(A) Item No.	(B) Document/Drawing No.	(C) Sheet No.	(D) Rev. No.	(E) Title or Description of Data Transmitted							
1	WHC-SD-TP-SEP-051	NA	0	Safety Evaluation for Packaging (Onsite) for the Concrete-Shielded RH TRU Drum for the 327 Postirradiation Testing Laboratory

Safety Evaluation for Packaging (Onsite) for the Concrete-Shielded RH TRU Drum for the 327 Postirradiation Testing Laboratory

ENGINEERING CHANGE NOTICE Pacific Northwest Laboratories (Reference FNL-MA-90)		1. CIN D01504	11P -01	R -0	IMP -00	LCR -01
		Page 1 of 9				
2. Project Title/Number/Work Order Number (See Page 2 for details) Concrete-Lined Waste Package/BE1257			3. Location 327	4. Date 10-10-96

ENGINEERING CHANGE NOTICE Pacific Northwest Laboratories (Reference FNL-MA-90)			1. JIN D01504	EDP -01	R -0	FMP -00	ECN -02
Page 1 of 4							
2. Project Title/Number/Work Order Number (see Page 2 for details) Concrete-Lined Waste Package Sleeve/BE1297			3. Location 327	4. Date 10-10-96

ENGINEERING CHANGE NOTICE Pacific Northwest Laboratories (Reference FNL-MA-90)	1. JCN D01504	ICP -01	R -0	IMP -00	LCN -01
					Page 4 of 9

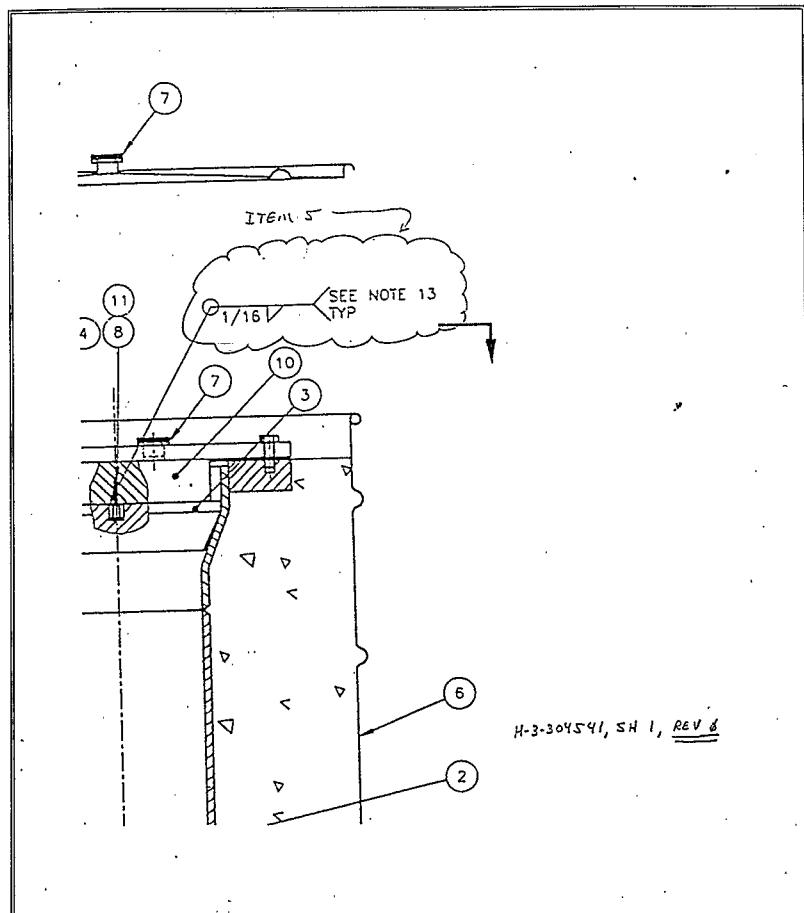
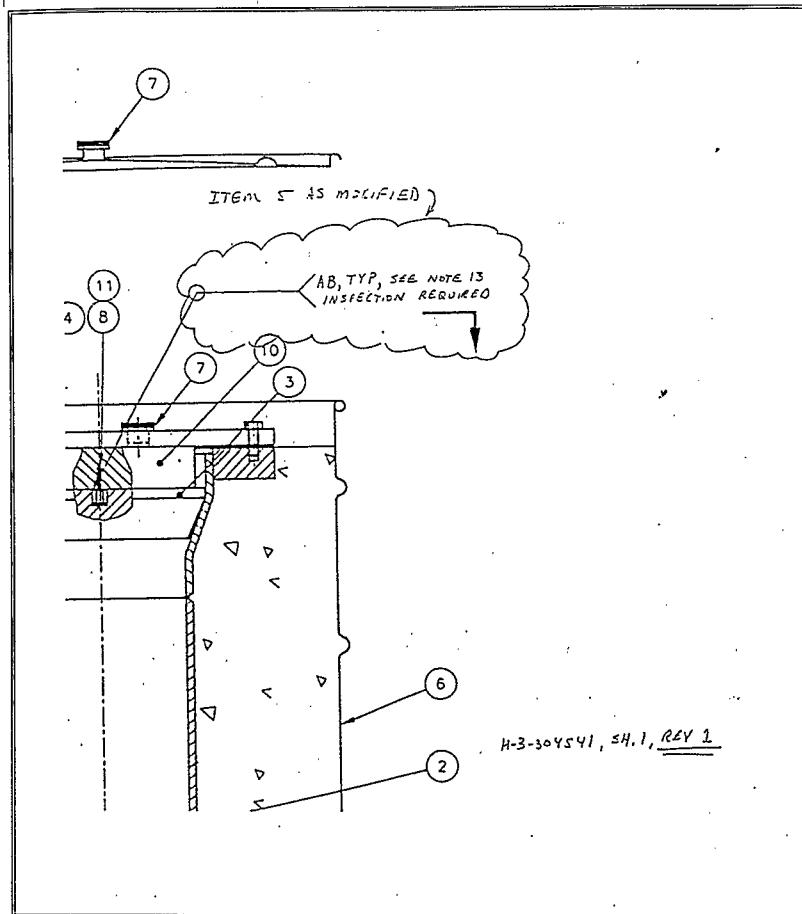
From: See sketch on page 4 (Rev 0 condition).
 To: See sketch on page 5 ("AS MODIFIED" condition).

ENGINEERING CHANGE NOTICE Pacific Northwest Laboratories (Reference PNL-MA-903)		1. JIN	EDP	R	IMP	ICN
		DE1504	-01	-0	-00	-01
		Page 6 of 9

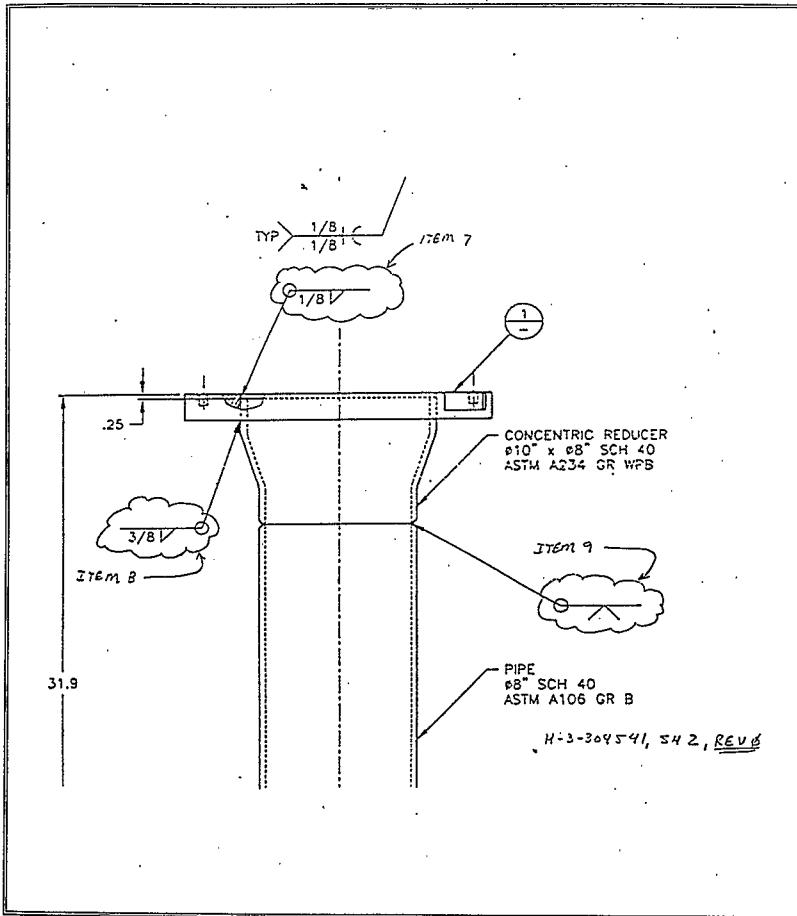
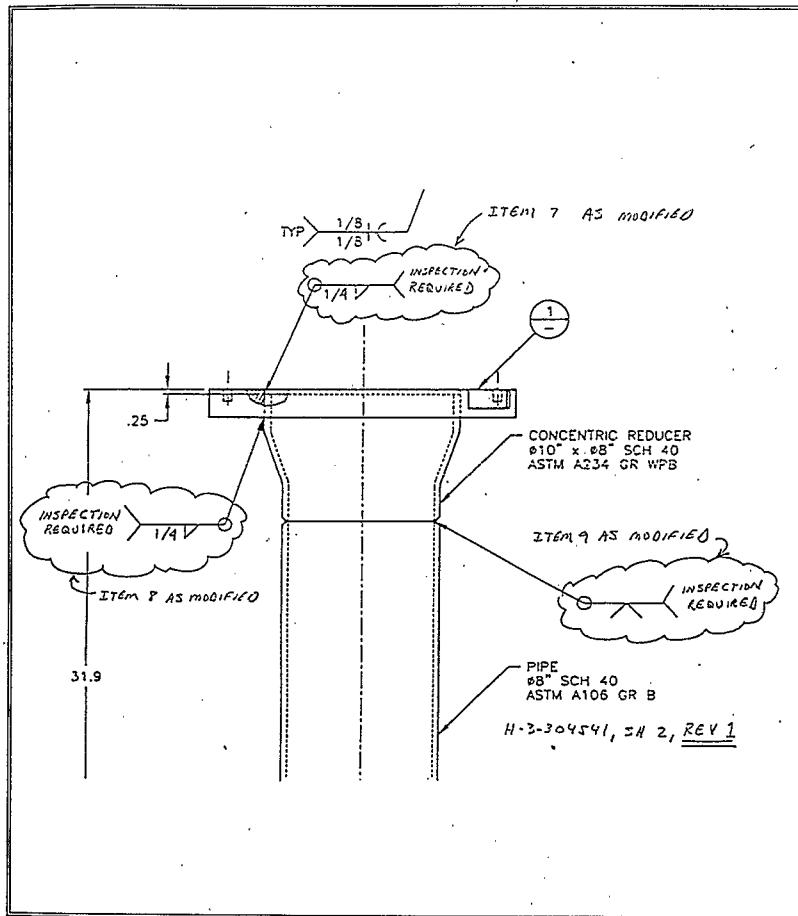
From: See sketch on page 6 (Rev 0 condition).
 To: See sketch on page 7 ("AS MODIFIED" condition).

From: See sketch on page 6 (Rev 0 condition).
 To: See sketch on page 7 ("AS MODIFIED" condition).

Item 9: Modify the welding symbol in zone D11 (for PW 2)
 From: See sketch on page 6 (Rev 0 condition).
 To: See sketch on page 7 ("AS MODIFIED" condition).

ITEM 15

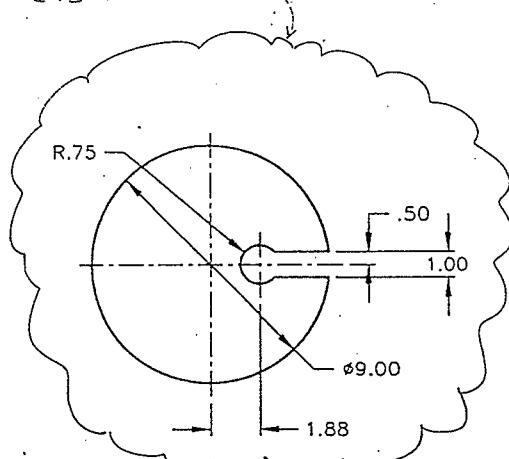
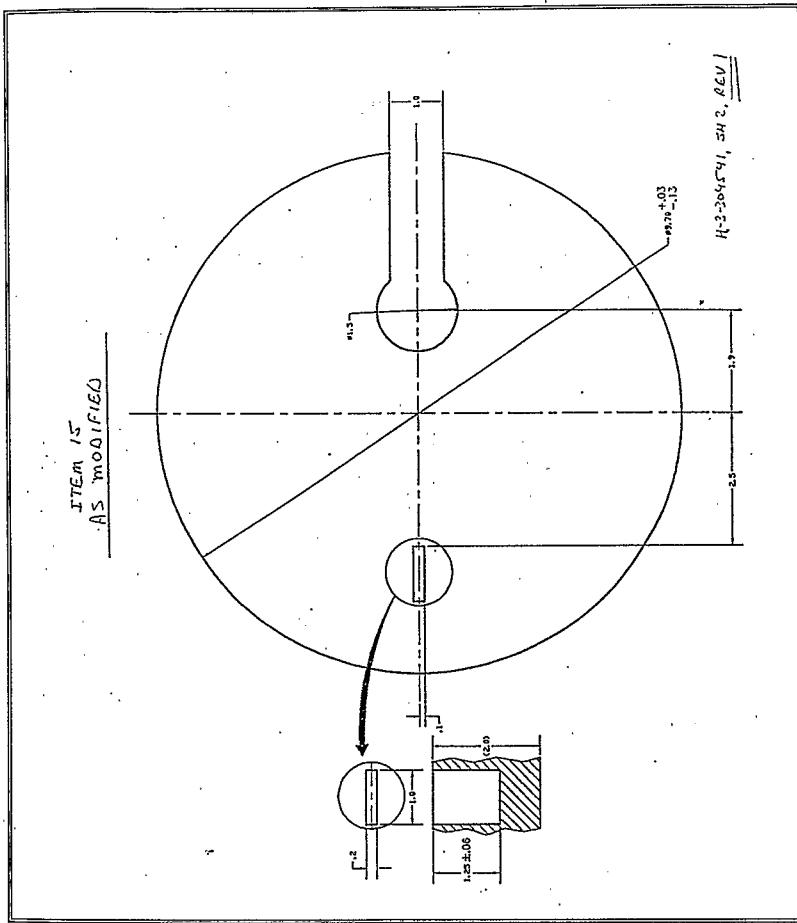
Item 15: Modify PW 10 as indicated below:
 From: See sketch on page 8 (Rev 0 condition).
 To: See sketch on page 9 ("AS MODIFIED" condition).

MATL: 2.0" THK
POLYURETHANE FOAM
LAST-A-FOAM FR-6704
4 LBS PER CUBIC FT

ENGINEERING CHANGE NOTICE Pacific Northwest Laboratories (Reference PNL-MA-90)	I. JIN D01504	EDP -01	R -0	FHP -00	ECN -02
Page 3 of 4

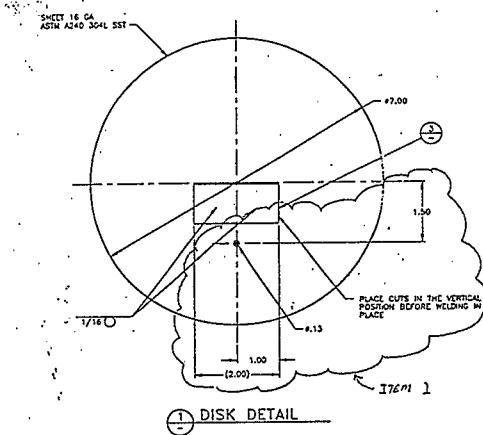
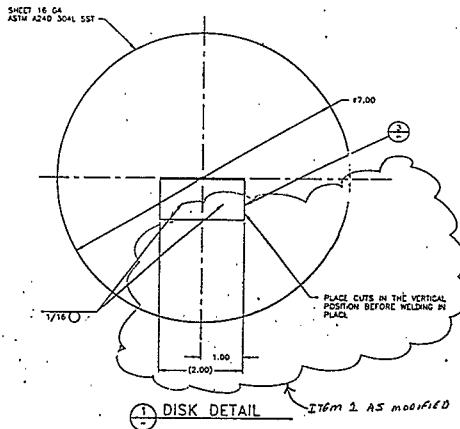
Item 1: Remove the ϕ .13 hole and associated dimensions from the "DISK DETAIL" in zone EF7-8.
 From: See sketch on page 3 (Rev 0 condition).
 To: See sketch on page 4 ("AS MODIFIED" condition).

Vent hole in cover (disk) has been judged to be unnecessary in consideration of overall sleeve assembly's closure mechanism (tabs). Modified weld inspection requirements allow for inspection of a representative sampling of closure and handling tab welds.
